Information Only Service Note

U9405A – i1000 Small Foot Print Inline systems

The Problem – Top rail bumper block(U9405-30302) causing delays on conveyor movements.

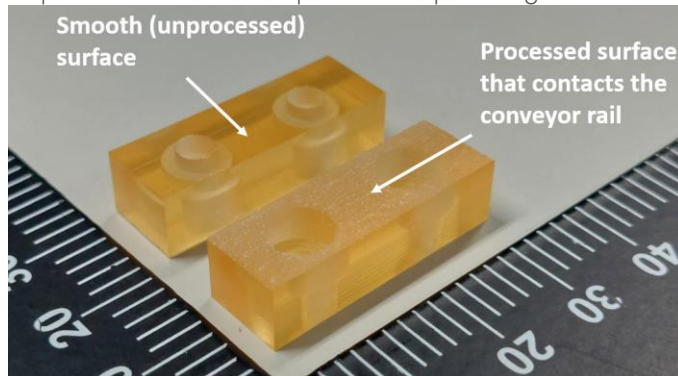
Downward movement of the conveyor rails between the fixed and movable rail becomes unsynchronized after the system is left idle while waiting for the next board to arrive. This results in the board dropping from the conveyor rail before it sits onto the test fixture. The issue happens when the idling time is about 30mins or more. There is no issue if the arrival of boards to the system is continuous.

The cause of the problem is the smooth surface of the top rail bumper block(U9405-30302).

When the conveyor is at the UP position waiting for boards, the cylinder constantly pushes the rail up against the bumper block. If this continues for extended periods of time, the bumper block starts to stick to the conveyor rail. When the next board arrives and conveyor tries to move downwards, the stickiness will delay the movement as it takes slightly longer for the air pressure to break free from the bumper block. This causes the unsynchronized movement and result is dropping of boards from the conveyor.

The top rail bumper block(U9405-30302) will be processed to roughen up the surface which meets the conveyor rail. This eliminates the possibility of the conveyor rail sticking to the bumper block regardless of batch variances.

Implementation of the processed part begins on 1st Jun 2024 starting with serial number TW61320102.
